BELGIUM Signalling

Charleroi, April 27th 2020

Subject: processing of Immediate Level Transition for ETCS onboard

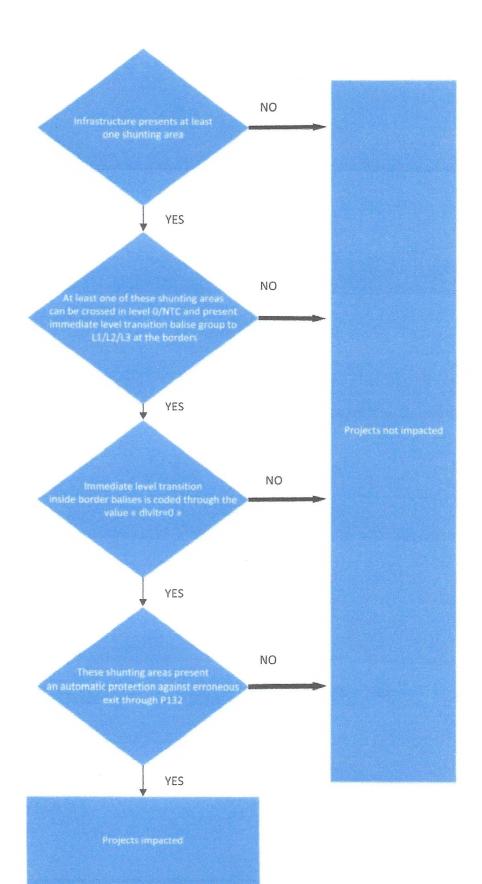
The attached flowchart enables to assess if the potential risk to leave a shunting area while still in shunting mode exists or not.

Should the potential risk be present, our suggestion to avoid any hazard is to adapt the procedure for requesting immediate level transition by using the special reserved value "NOW" for the D_LEVELTR parameter.
